- 1. North 20 Subdivision AHO Replat
KPB File 2022-152**

KPB File 2022-152
T 05S R 12W SEC 27
Fritz Creek

ITEM 1 – NORTH 20 SUBDIVISION AHO REPLAT

KPB File No.	2022-152
Plat Committee Meeting:	October 24, 2022
Applicant / Owner:	David Kudwa, Joe Whitteberry, and Ting Fang Wang all of Homer, AK
Surveyor:	Christopher Mullikin / Mullikin Surveys
General Location:	Pyrenees Way, Lulu Court, Fritz Creek area

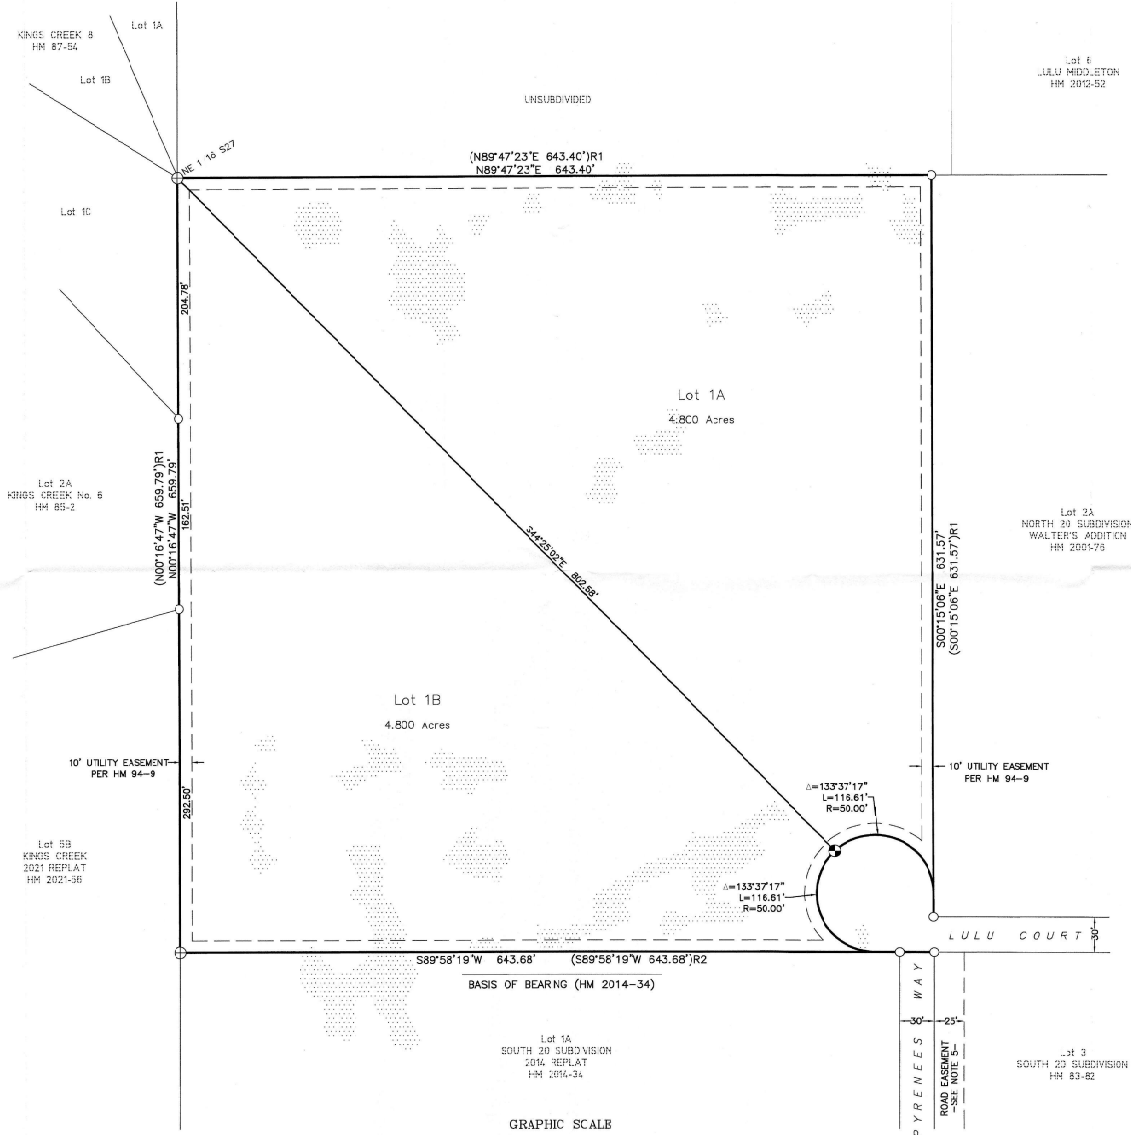
Site Investigation: The subdivision contains gradual slopes to the south that are consistent throughout with a few areas of slopes with more than 20 percent grade. This areas are depicted on the preliminary plat. As some of the steeper slopes are present within Lot 1B’s access area, **staff recommends the steep slopes remain on the final plat and the depiction symbol be slightly increased in size to make more discernable on future copies.**

Staff recommendation: All owners with their address must be within the title block.

Staff recommendation: Some of the lot designations contain hyphens per their plat.

Staff recommendation: *Depict the setback or provide a typical depiction.*

Platting Staff Comments: Soils report is not required due to the size of the lots. Update the wastewater disposal plat note to comply with current code.

Staff recommendation: *The segment above Pyrenees Way should not be part of the subdivision boundary.*

Update plat note 6 by removing "or nominal five acres".

Staff recommendation: *The owners' names should match how they took title and the certificate to plat has them listed. Add another notary acknowledgement or provide another blank for a third name if all signing at the same time. Comply with 20.60.190.*
